TENNESSEE VALLEY AUTHORITY

June 25, 1985

Please refer to your letter to H. G. Parris dated September 14, 1984 which requested that additional information be provided on the Watts Bar Safety Parameter Display System (SPDS) in the areas of instrumentation and control systems and human factors engineering. TVA's letter of March 27, 1985 provided the requested information pertaining to instrumentation and control systems. Enclosed is the requested information regarding human factors engineering.

WATTS BAR NUCLEAR PLANT
HUMAN FACTORS ENGINEERING INFORMATION

Number: F-0	Title: CRITICAL SAFETY FUNCTION STATUS TREES	Rev. Issue/Date: HP/LP, REV. 1 1 Sept., 1983
----------------	--	--

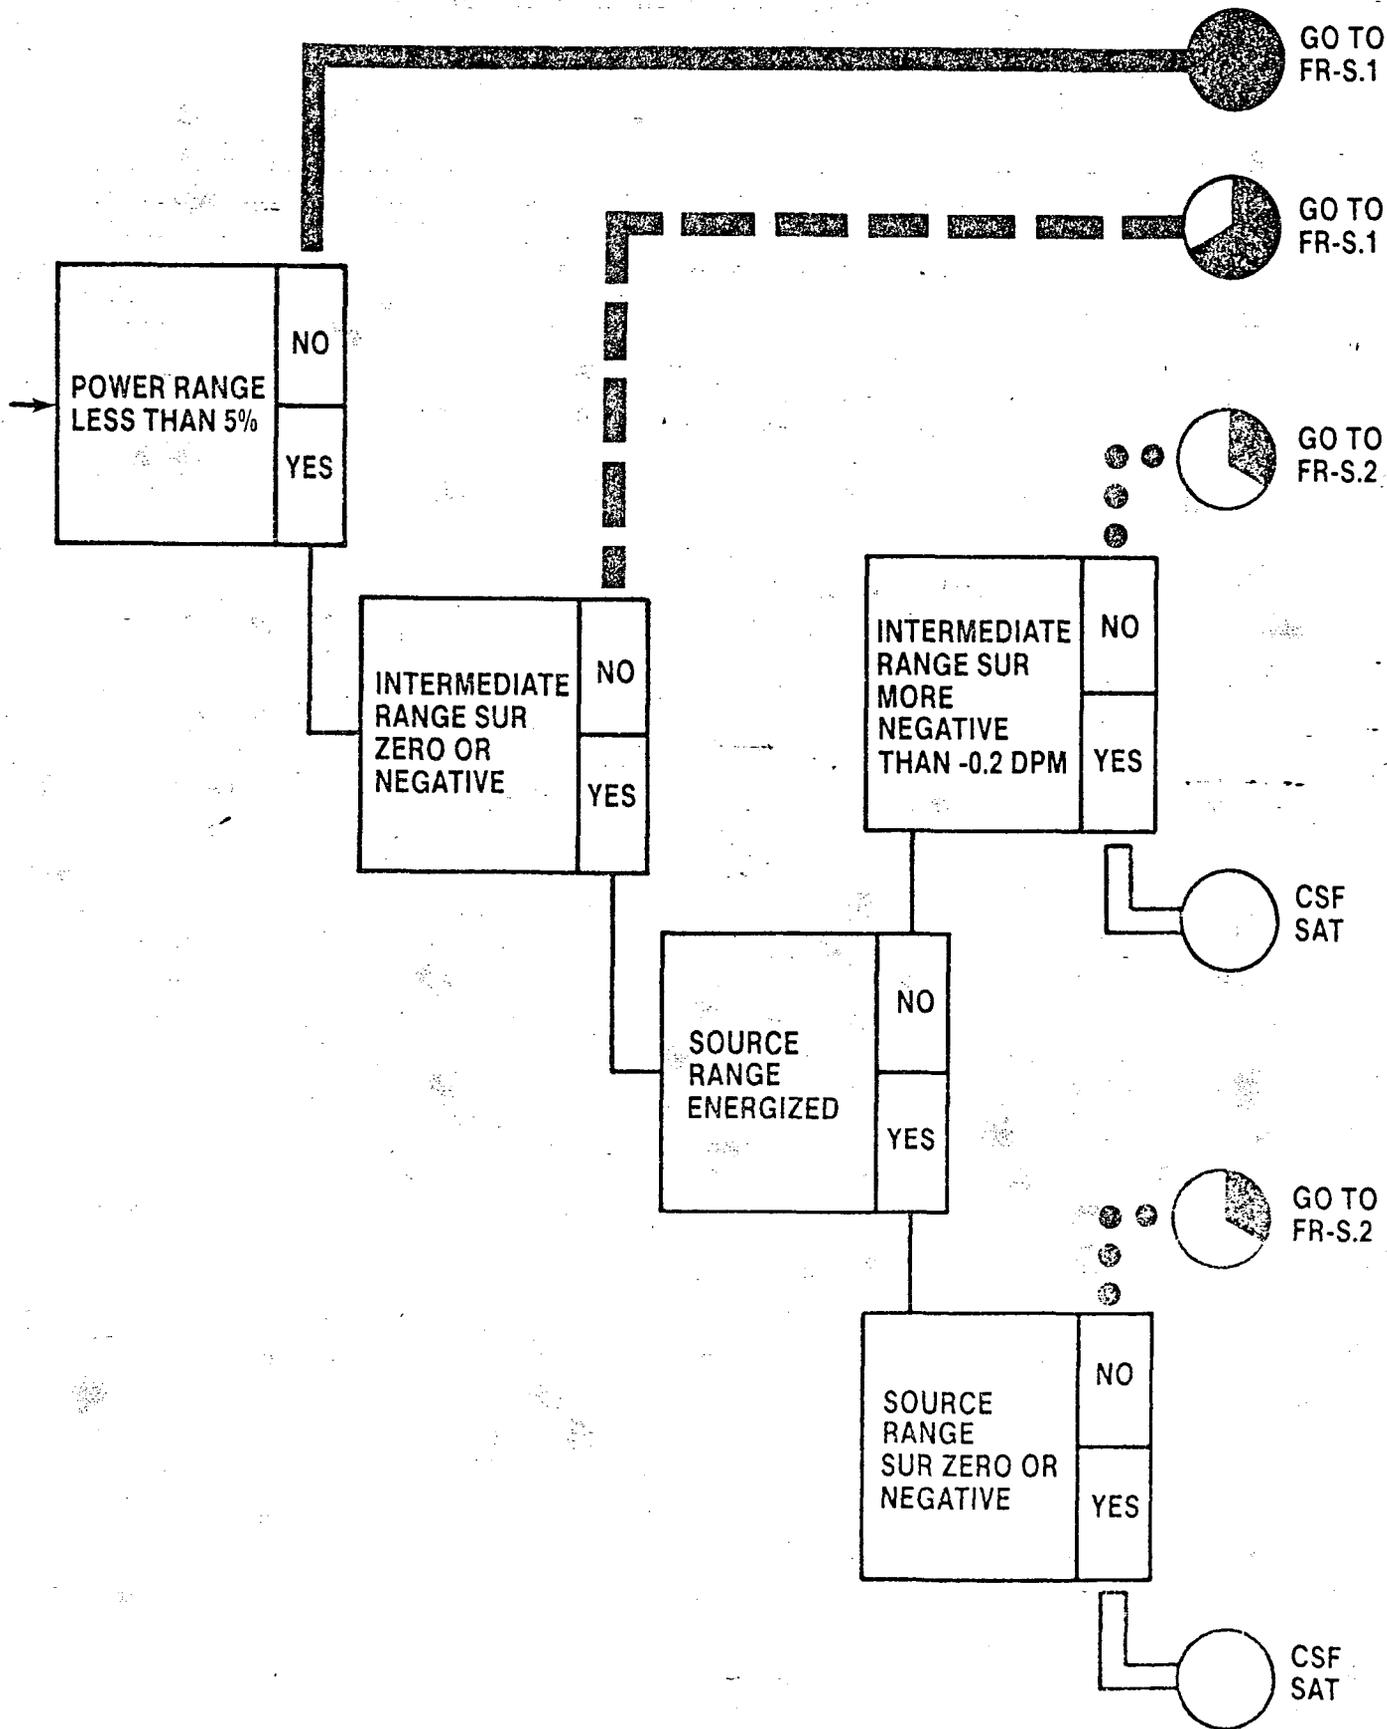
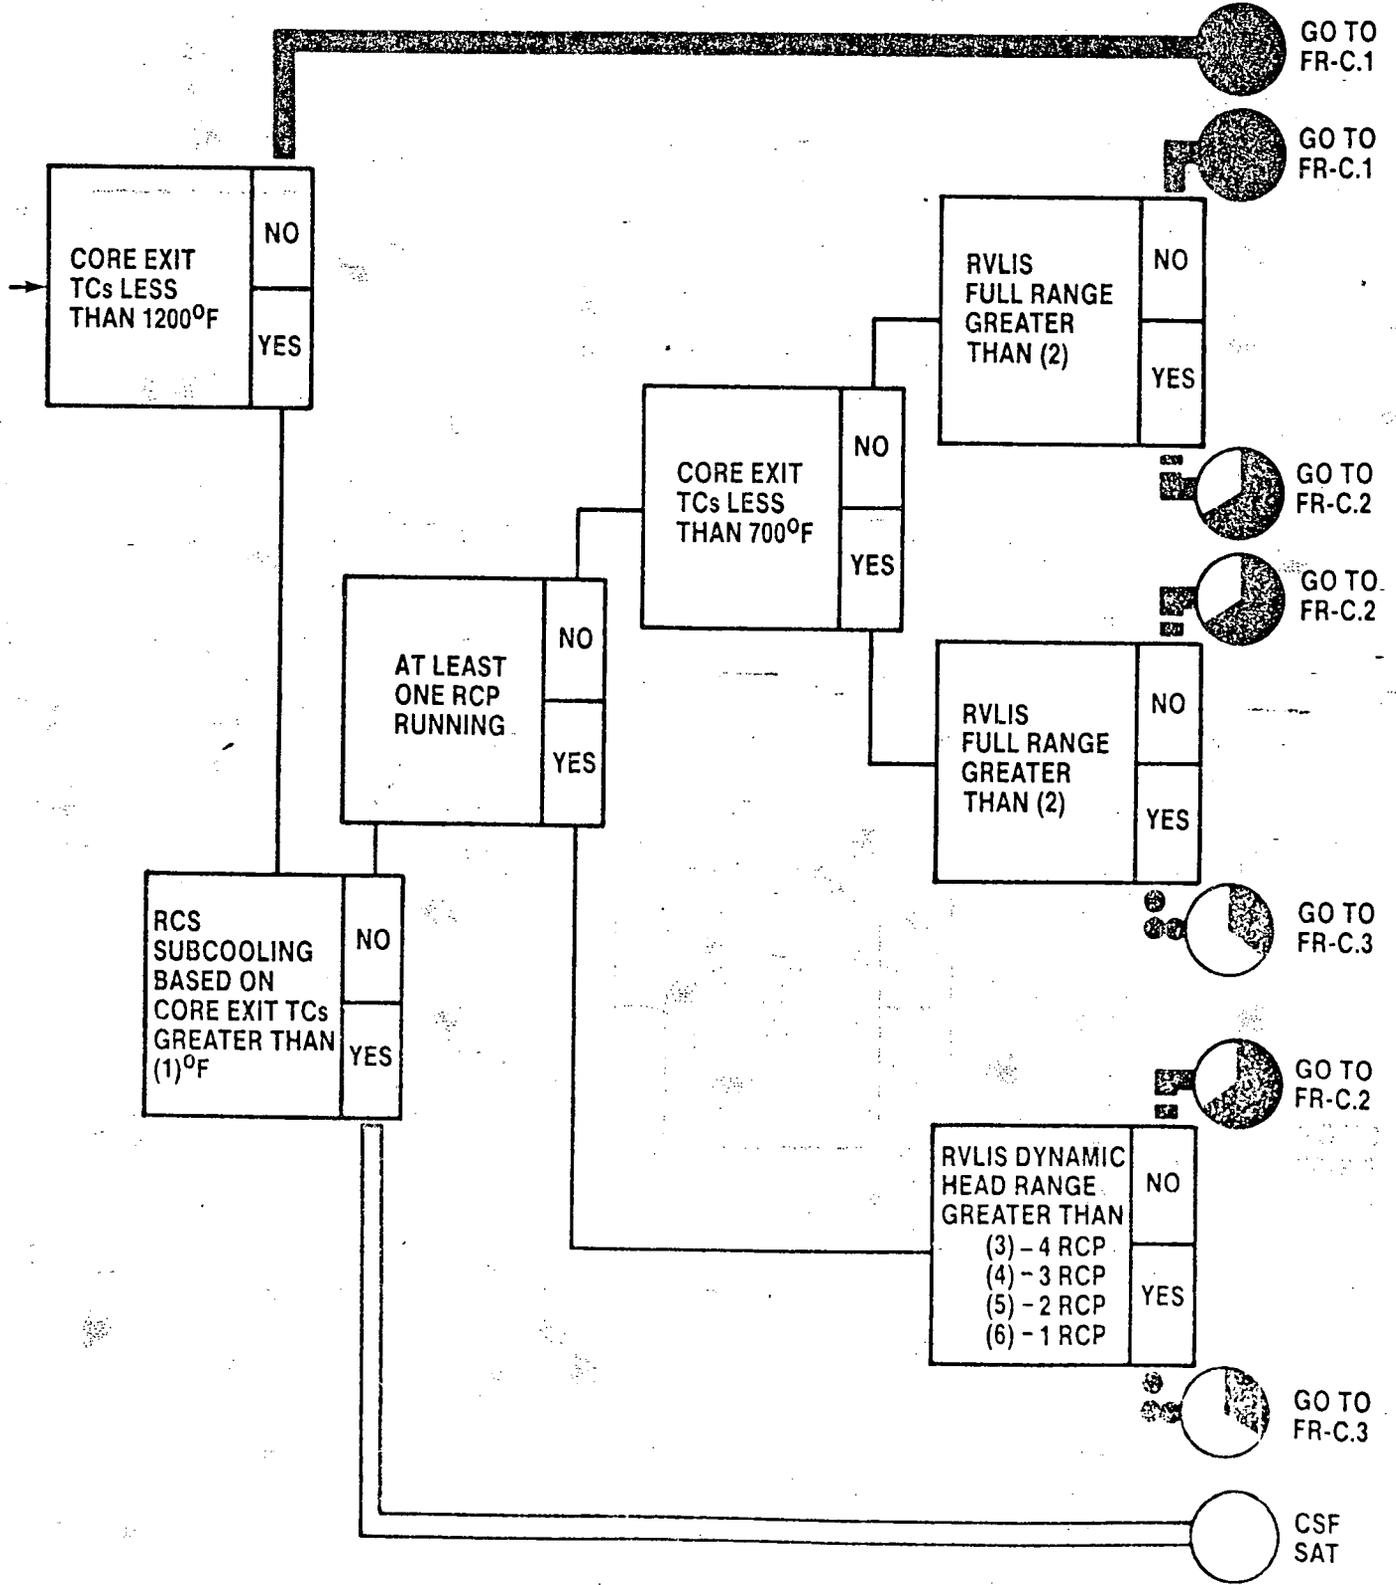
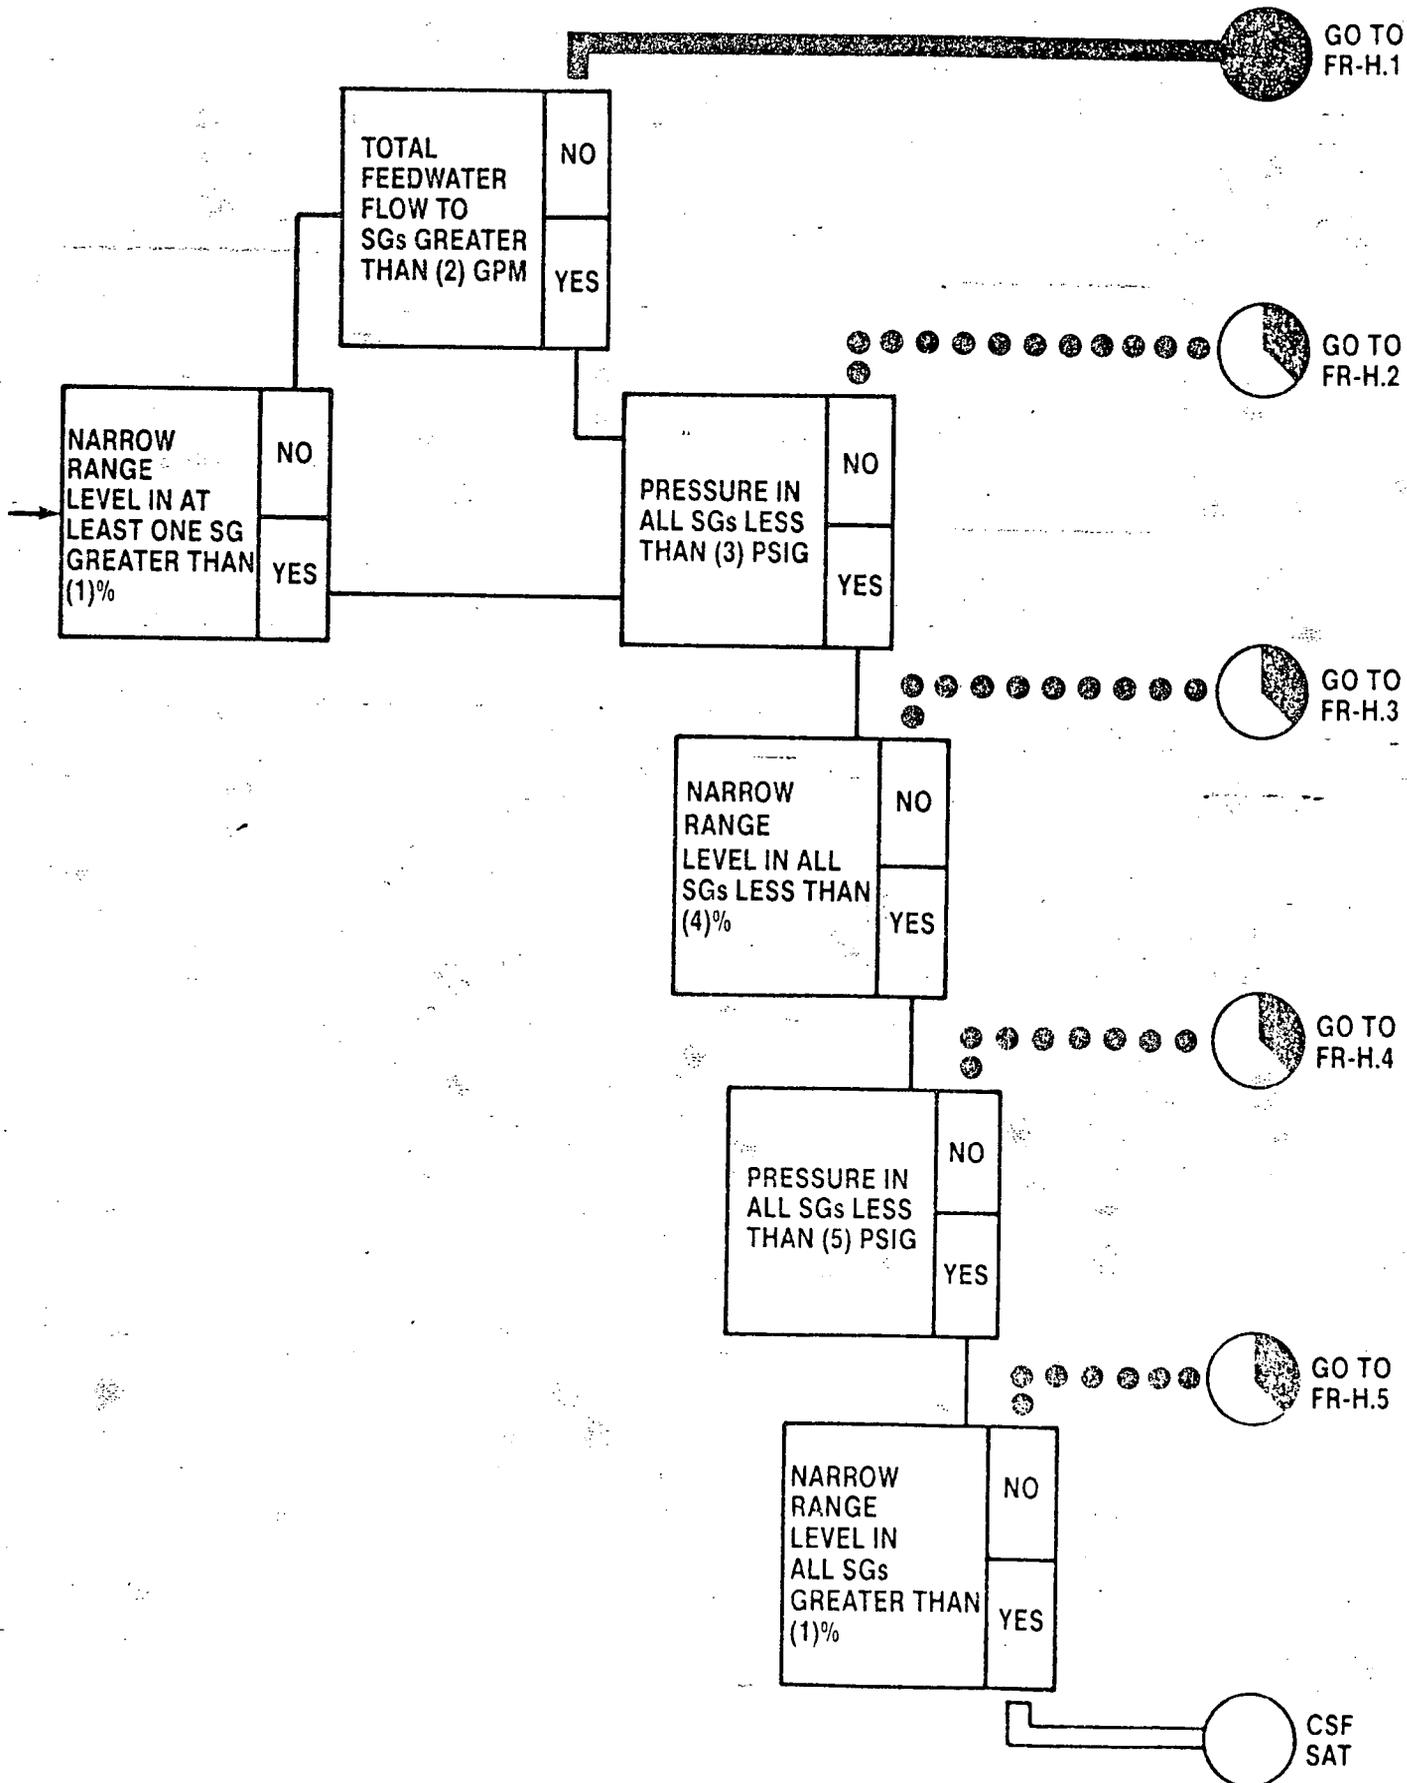
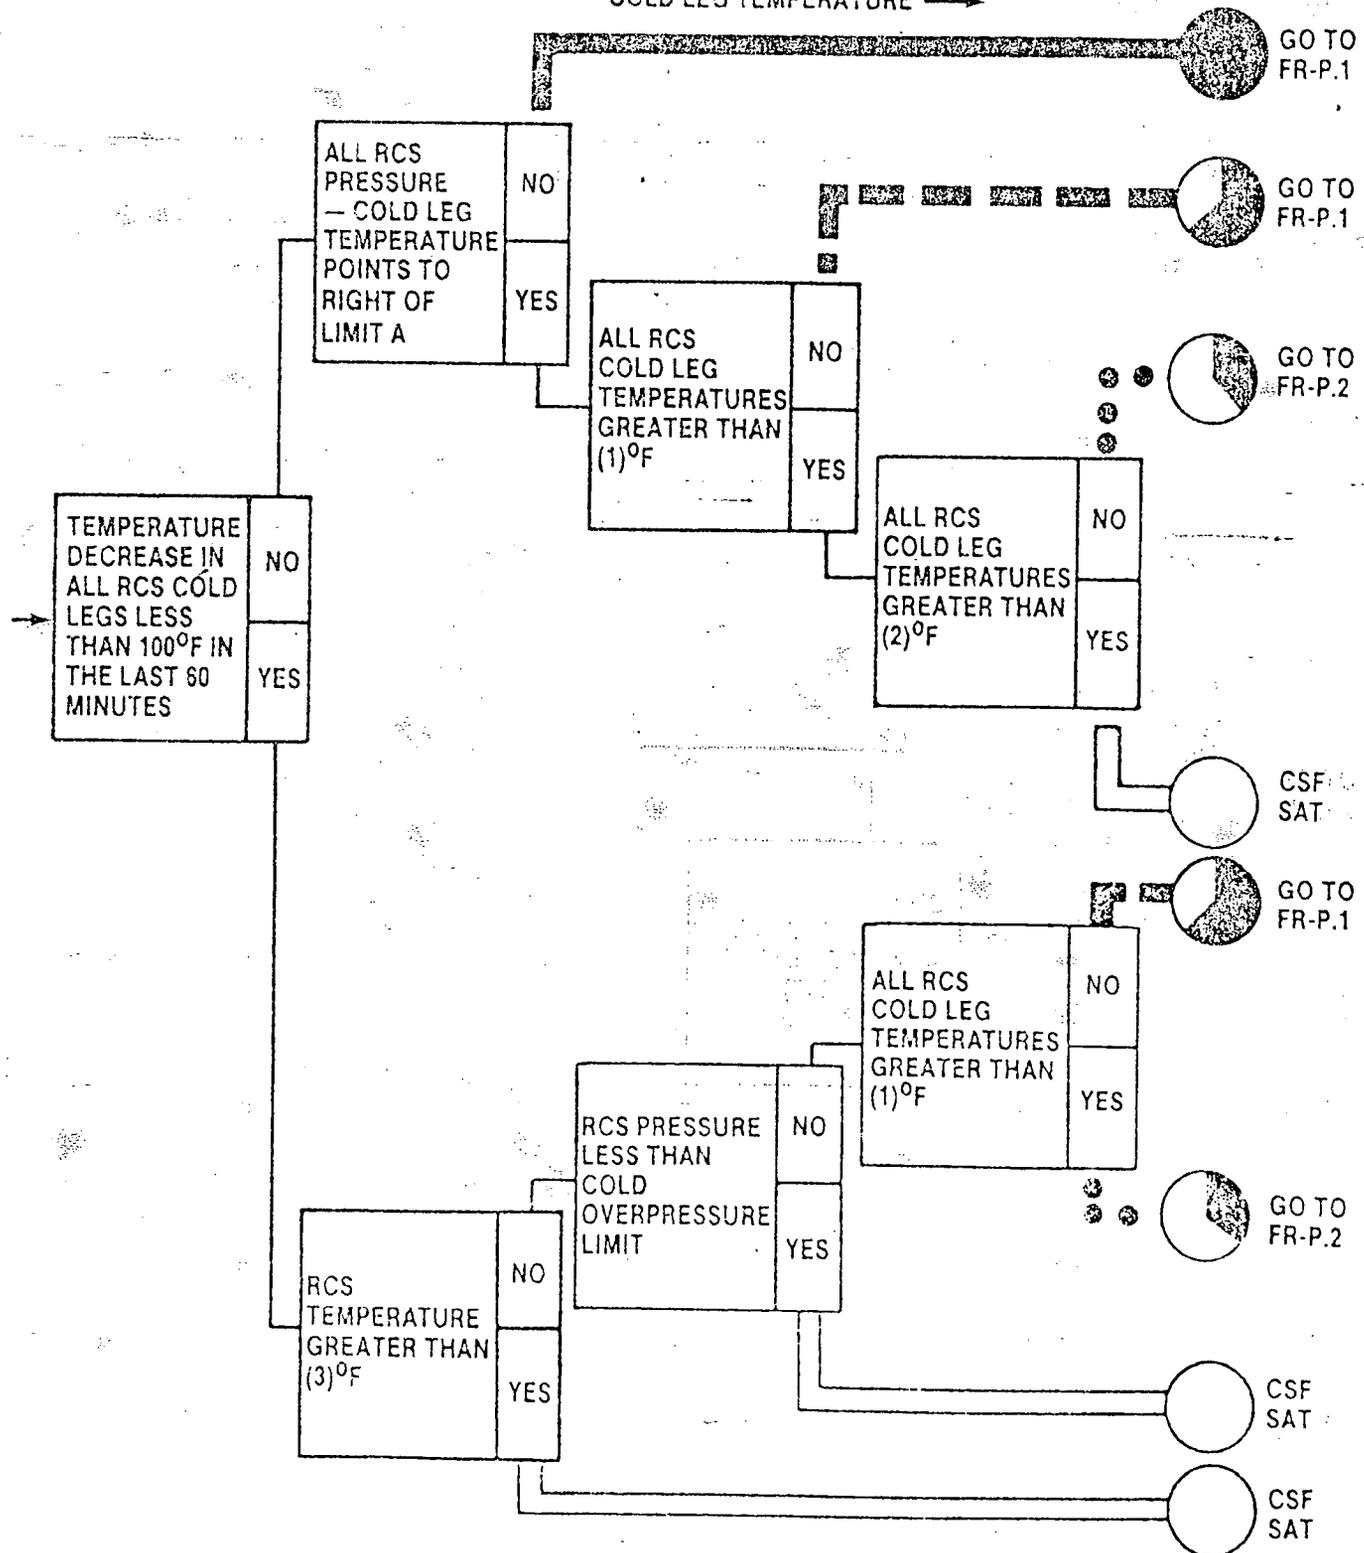
Provide a description of the display system, its human factored design, and the methods used and results from a human factors program to ensure that the displayed information can be readily perceived and comprehended so as not to mislead the operator.

The Safety Parameter Display System (SPDS) consists of the block type critical safety function status trees from the upgraded Westinghouse Owners Group (WOG) Emergency Response Guidelines (ERGs). Documentation for these status trees "Emergency Response Guidelines Revision 1" were transmitted to Hugh L. Thompson, Jr., Director, Division of Human Factors Safety, by the Westinghouse Owners Group on May 4, 1984.

Each tree uses several blocks containing questions with a yes or no output which leads to a status. When a status tree branch is not satisfied, it directs the operator to an appropriate function restoration guideline.

Six generic status trees from the WOG ERGs are attached. These trees will be converted to plant-specific trees for Watts Bar. The different branches are color coded to show the operator how serious any challenge is to a critical safety function. The ordering of the trees also defines priorities. The colors in order of priority are: red (solid line), magenta (dashed line), yellow (short dashed line), and green (double line).

When any status tree is displayed, colors are shown in a designated area, giving the status of the other five trees.

The critical safety function status trees have been developed using human factors principles. When the SPDS system is operational, the control room design review team will make a human factors review on the status tree displays.
